Contract #: 04-0120F4Cty: SF/ALA Rte: 80 PM: 13.2/13.9File #: 69.25B**QUALITY ASSURANCE -- NON-CONFORMANCE REPORT****Location:** Changxing Island, Shanghai, PRC**Report No:** NCR-000205**Prime Contractor:** American Bridge/Fluor Enterprises, a JV**Date:** 16-Oct-2008**Submitting Contractor:** Zhenhua Port Machinery Company, Ltd (ZPMC), Changxing Island**NCR #:** ZPMC-0183**Type of problem:**

Job Name: SAS Superstructure

Subject: NCR No. ZPMC-0183

Reference Description: PJP Non uniform groove face

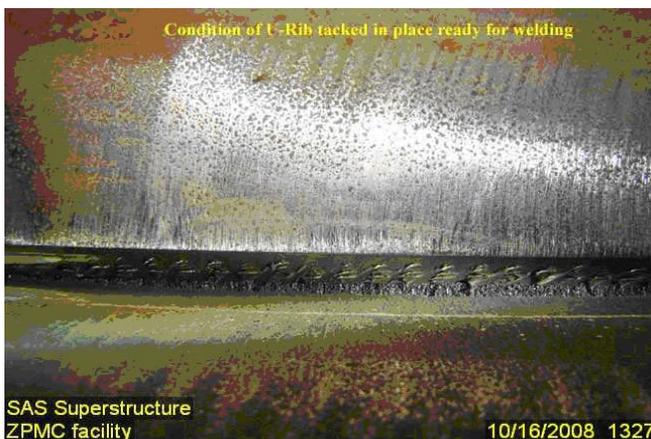
Surfaces to be welded do not conform to workmanship requirements for preparation of base metal. Groove faces of closed ribs welded to deck panels were not smooth or uniform. This is typical on all U-Ribs that have been manufactured to date. Please reference NCR-ZPMC-0070 dated Feb. 15, 2008. The Contractor has indicated (via ABF-CAL-LTR-000626, dated 14 August) that the nibbler teeth would be replaced on a more frequent basis, and that surfaces would be repaired via grinding before welding. This remain, however, an ongoing issues. Included below are digital pictures of the closed rib PJP groove face discrepancy.

AWS D1.5, Section 3.2.1: "Surfaces and edges to be welded shall be smooth, uniform, and free from fins, tears, cracks, and other discontinuities which would adversely affect the quality or strength of the weld. Surfaces to be welded and surfaces adjacent to a weld shall also be free from loose or thick scale, slag, rust, moisture, grease, and other foreign material that would prevent proper welding or produce objectionable fumes."

As shown in the photos and physically verified, it appears that the equipment should be adjusted as the surface profile deteriorates, CT has quoted AWS D1.5 Section 3.2.1 stating surfaces and edges shall be smooth, uniform etc.. so as not to adversely affect the quality of strength of the weld. ABF does not agree that the surface profile shown will affect the quality and strength of the weld, however, ABF does recognize that some of the dimensions of the weld preparations shown do not comply with the welding procedure/fabrication plan and request ZPMC to make the necessary adjustments for this purpose.

The response is acceptable, but the Non-Conformance is not closed.

Please provide documentation that the welds are acceptable. The Department will review the Contractor's proposal to close Non-Conformance ZPMC-0183 at that time.
